# TECHNICAL BULLETIN

No: J018  
Issue: 1  
Date: 15 JUNE 2011

### Safety Recall: Power Assisted Steering Pipe Corrosion Protection

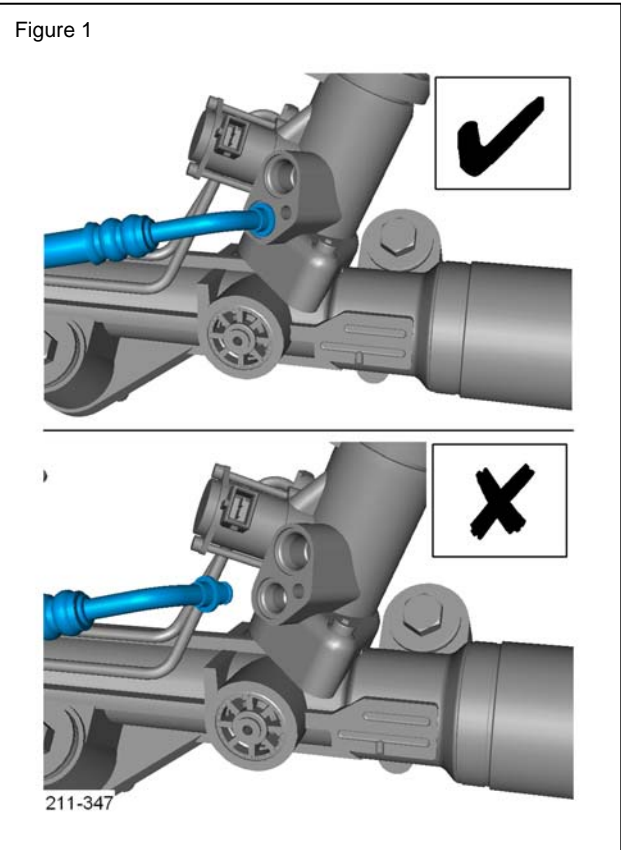
**⚠ CAUTION: Do not release the return hose from the steering gear; failure to follow this instruction may result in damage to the O-ring seal. (Figure 1)**

1. Refer to Workshop Manual, section 211-02: *Power Steering*, and replace the Power Steering Pump to Steering Gear Pressure Line.
